CABINET MEMBER FOR ENVIRONMENT – 16 JULY 2020

SUTTON COURTENAY – MILTON ROAD: PROPOSED SHARED USE FOOTPATH / CYCLETRACK

Report by Interim Director of Community Operations

Drawing Title: SVCN Section 3D Shared Use-Footway Consultation

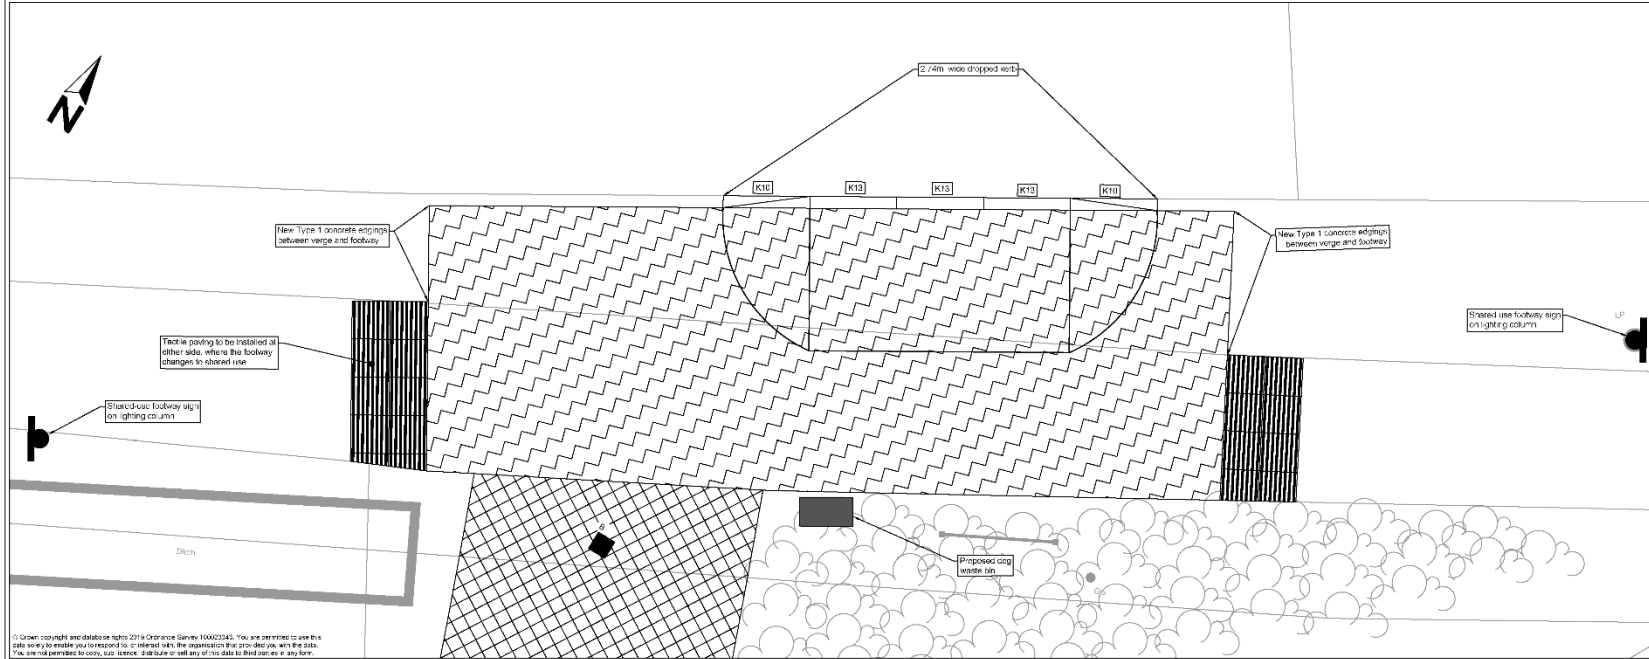
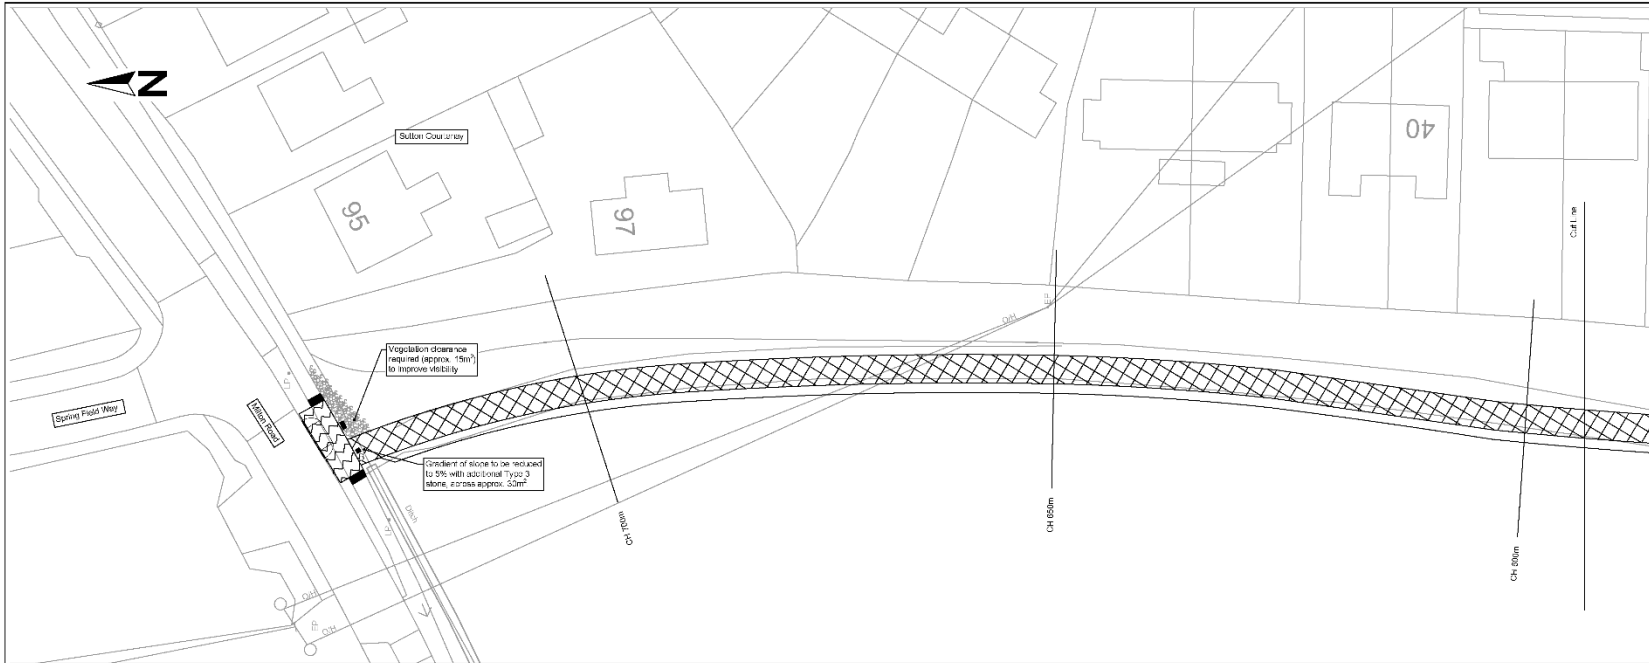
8. Cycling UK and Oxford Cycling network supported the proposal but suggested an amendment to the detail to facilitate access to and from the off-road traffic for cycles with trailers etc. to from Milton Road west of the junction with the off-road route. The scope to accommodate this suggested change will be investigated.

9. One objection was received from a member of the public on the grounds that a signalled crossing is required with appropriate detection of approaching cyclists given the limited visibility available for cyclists travelling north on the off-road cycle route as they approach the junction with the Milton Road. While noting this concern, the proposed uncontrolled crossing point is judged to be appropriate taking account of the visibility, traffic flows and speeds on the Milton Road and noting that uncontrolled crossings of this type are provided at many similar access points to off-road cycle routes – including those with similar visibility - and these have been found to operate with acceptable safety.

10. An expression of concern was received from a member of the public stating that they would like to see a separate cycle and pedestrian path and not a combined one. It should be emphasized that the proposed short length of shared use footpath/cycle track is required to assist cyclists joining and leaving the off-road cycle route and that some potential interaction between pedestrians and cyclists is unavoidable in this situation, However, experience of other shared use cycle tracks has been that both pedestrians and cyclists follow the advice set out in the Highway Code on the use of such facilities and it is not anticipated that there will be difficulties here.

(3) South & Vale District Councils, (Planning)	Support – The District Council is supportive of the proposal.
(4) Resident, (Abingdon)	<p>Object – I write to object to the proposal to terminate section 3D of the upgraded cycle path north/south from Milton Park to Milton Rd Sutton Courtney on the grounds that with nil visibility of road traffic to the east until arrival at the junction, there is no safe way to approach the junction from the cycle path if it terminates and dumps bicycles onto the road.</p> <p>I urge instead that on safety grounds, a new pelican crossing with traffic lights be installed near to OS 494 927 at the end of bike path section 3D and the site of the proposed works, which presumably your office are the right people to specify.</p> <p>I further propose that bike motion sensors wired parallel to the usual pushbutton on pelican crossings be set so that bikes at a design speed of 25 km/h and not less than half that get a little green man at the crossing and go straight on North to proposed fast cycleway section 3C toward Abingdon.</p> <p>Whilst the 1970's wiring diagram of the pelican crossing from the TRRL might be lost or unavailable, I could start work on that immediately if requested to do so.</p> <p>One way in which this would differ from a usual pelican crossing is that for a North/South design speed of 25 km/h, absolutely flat crossing and road surfacing for the bikes should be specified. Pedestrians should have visibility and signage which does not lead to their stepping into the path of bikes. The pedestrian path might ramp down a few inches to the fast cycle path at either side of it. For 25km/h, the cycle path must not ramp at all.</p>

(5) Local Resident, (Sutton Courtenay)	Concerns - We need a separate cycle path and pedestrian path, not a combined one.
(6) Local Resident, (Sutton Courtenay)	Support - Strongly support this proposal and the cycle path plan to Milton Park. No-brainer. Please make sure that those with irrational fears about cyclists or the vocal minority do not scupper these plans. Serious consideration should also be given to how these proposals can usefully link with NCN5 at Peep O Day Lane by using Footpaths immediately north of these proposals (373/21, 192/10, 373/17). There should be more appetite to secure land and / or convert existing footpaths which provide direct links to major employment areas to encourage sustainable transport options.

(10) Cycling UK Oxfordshire	Support - This scheme will be a welcome addition to the cycle network in this area. I have one issue to raise, the access alignment is not good from one direction. Approaching from/exiting to Sutton Courtney is fine. Anyone approaching from the west (from Milton Road) has rather a tortuous route to back track when making a turn. This would be made worse if using a child trailer/tag along to get their child to nursery as part of their commute to work. There should also be an entry/exit ramp immediately to the west of the cycle track. Something on the line of the access point photo attached. This shows the sort of layout, even if in this case the small print (or lines/tactile slabs) of the photo

<p>say one of the lowered kerbs is for pedestrians. It is one of those details that change a facility from a facility into a well-designed facility.</p>
(11) Oxfordshire Cycling Network	<p>We support the general proposal that there is a 10-metre section of shared use track and a junction at this point.</p> <p>The track specification looks good and the bollard should be passable by larger and 'inclusive' cycles.</p> <p>However, we think the junction could be better designed to support all the possible cycling movements. Specifically this design makes it very difficult to enter or exit the new track from the west.</p> <p>Shifting the dropped kerb to align with the track would achieve this. Even better would be to build in a 'protected exit' to the west. A sketch is attached to clarify this.</p>
